# STANWIX RURAL PARISH COUNCIL

**Appn Ref: 23/0347**

**Location: Land at Brunstock Lane, Houghton, Carlisle**

**Proposal: Residential Development Consisting Of 163no. Dwellings & Associated Infrastructure**

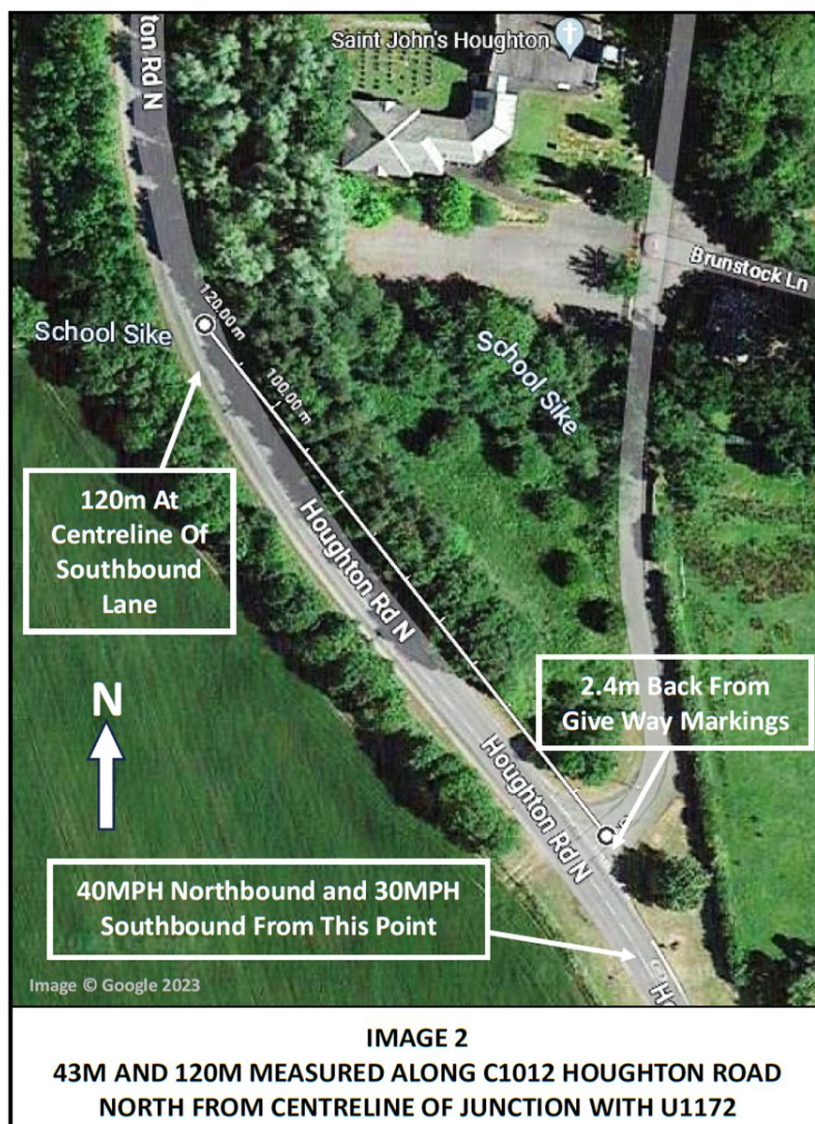
- 2.1 The proposed primary access would be a new 6m carriageway off Church Lane, from the C1012(101) Houghton Road North. A secondary access, also proposed for use by emergency vehicles, would be via the Public Right of Way, Footpath 132013, U1238 (101) from the U1238 (101) Jackson Road – both IMAGE 1, below.

- 2.3 Leaving the village the C1012 (101) Houghton Road North is subject to a 40MPH speed limit. No alternative speed limit signage applies to the U1172 (101) – IMAGE 1 above. With the exception of one street lighting column, near its junction with the C1020 (101), the U1172 is unilluminated. The U1172 (101) is therefore also subject to a 40 MPH (64.37KPH) speed limit, or may be unrestricted.

2.15 A secondary/emergency access is proposed via existing Public Right of Way, footpath 132013, from the U1238 (101) Jackson Road. Footpath 132013 has a width of approximately 4m, this width being constrained by the boundaries of the adjoining dwellings and of the Electricity Sub-Station, and is accessed from the U1238 (101) Jackson Road which has a measured kerb to kerb width of only 4.9m – IMAGE 1.

**IMAGE 6**  
**INFORMATION PROVIDED BY APPLICANT**  
**AT DROP-IN SESSION 28 JULY 2023**

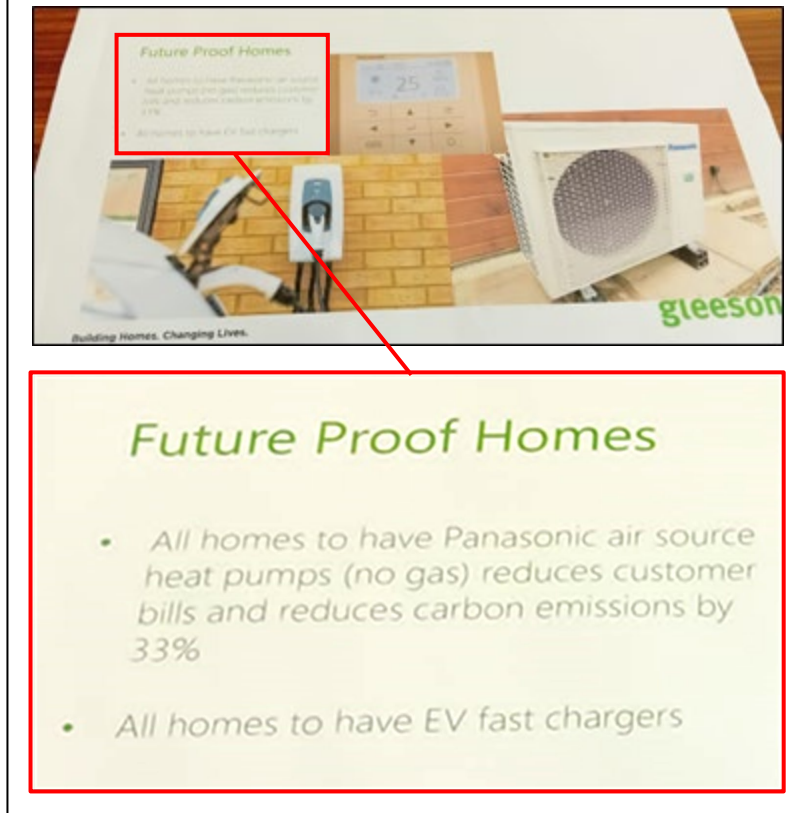
- 7.8 An air source heat pump generates approximately 40-60 decibels from a distance of one metre away. This decibel (db) range is often defined as:
- 40 db = refrigerator hum,

- 7.14 The intrusive cumulative noise impact on existing homes, and the environment of 163 air source heat pumps each generating 40db–60db, is not addressed in the applicant’s NIA or any other application document. The NIA is therefore wholly inadequate.
